Williston Conservation Commission

Conservation Commission Meeting, April 6, 2022
Review Stage: *Discretionary Permit*

Project Summary: This is a discretionary permit review of Phase I of a proposed 138-unit residential subdivision (27 single family units, 36 duplex units, 15 triplex units, 36 fourplex units and 24 sixplex units) with a road connection to Raven Circle and community amenities on a 58± acre parcel located at 1400 Mountain View Road in the Residential Zoning District (RZD). Phase I includes 60 dwelling unit equivalents (47 market rate and 13 affordable), Kourebanas Drive connecting Mountain View Road to Raven Circle, the stormwater system, and planned community facilities (community building, pool, playground, gardens).

ERF Prioritization/Desired Paths and Primitive Trails

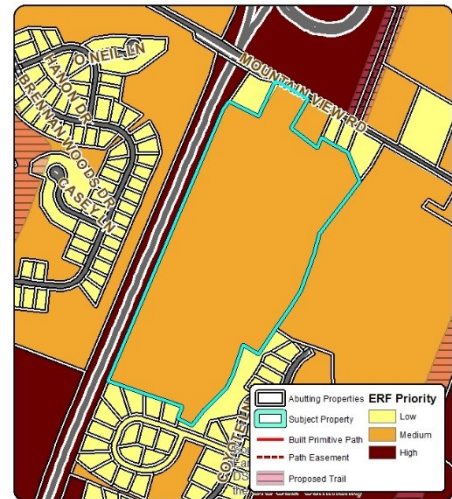
The parcel is assigned a conservation priority level of **medium** in the ERF Prioritization Map. There are no desired primitive trails shown on the property in Map 17 of the *Williston Comprehensive Plan*, and the applicant is not proposing any primitive trails or easements as part of this project. The applicant is proposing a paved multiuse path, shown on the site plan, to connect Raven Circle to Mountain View Rd.

WDB 27.9- Scenic Viewshed

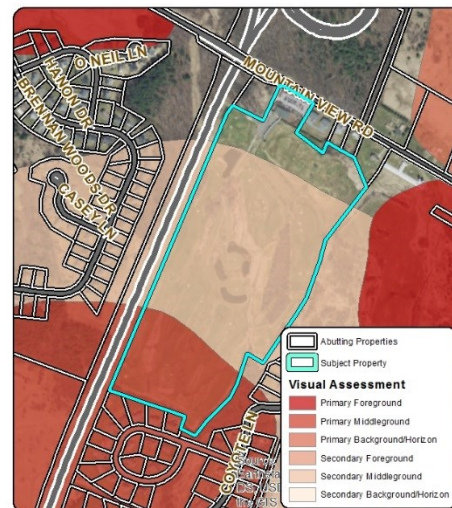
The subject parcel contains Primary and Secondary Middleground areas in the Visual Assessment Official Map. WDB 39.8.2.5 states that landowners who wish to develop parcels including scenic viewsheds will work with the Conservation Commission and DRB to maximize protection of the identified views. The houses are sited such that they are mostly screened from Mountain View Rd and abutting developments by existing forested vegetation, which will be supplemented by planted trees and shrubs.
